**BEFORE THE PUBLIC UTILITY COMMISSION  
OF OREGON**

LC 82

In the Matter of  
PACIFICORP,  
2023 Integrated Resource Plan and  
Clean Energy Plan.

ROUND 0 COMMENTS OF  
RENEWABLE NORTHWEST

**Figure 9.18 – Increase/(Decrease) in Proxy Resources when Offshore Wind is Added to the P-MM Portfolio.**

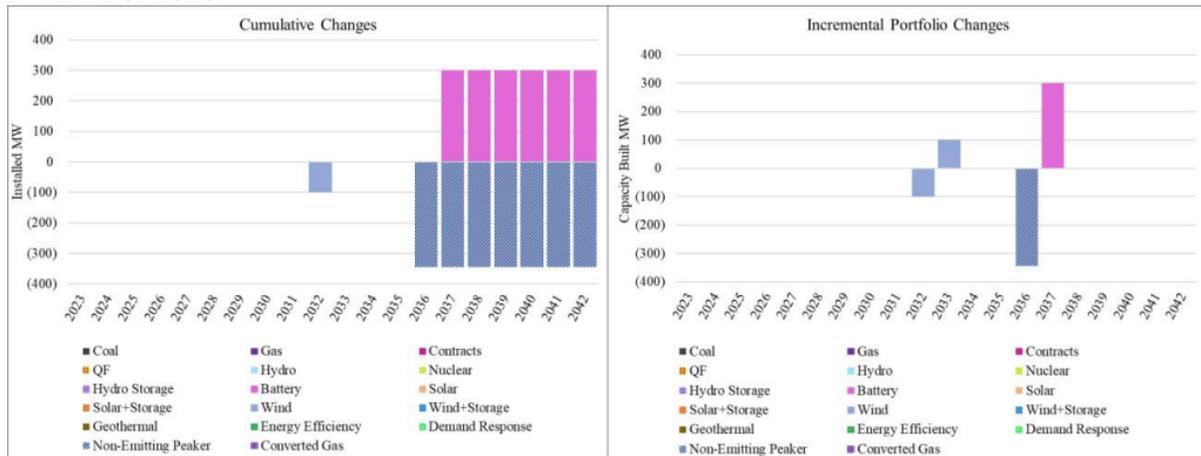
peaker resources and SMRs as discussed above, RNW suggests that OSW could be more of a “least regrets” resource selection for the post-2030 scenarios.<sup>15</sup>

RNW intends in our Round 1 comments to suggest areas for further analysis around the modeling of OSW and other post-2030 resources. OSW's significant scale and complementary generation profile (to other, existing and planned renewable energy resources) has the potential to change the shape of net peaks, creating an opportunity for greater utilization of short and long-duration energy storage instead of the capacity resources currently reflected in the Company's post-2030 portfolio. Indeed, this combination of OSW with expanded storage options may present a lower-regret alternative to meeting these net peaks than investing in SMRs and hydrogen peakers, both of which appear further from commercialization than long-duration storage. And the economics of OSW could be bolstered if modeled in conjunction with greater regional integration, particularly in the case of a western RTO. RNW is currently assessing potential sensitivities to further explore, and hopefully validate, these tentative conclusions.
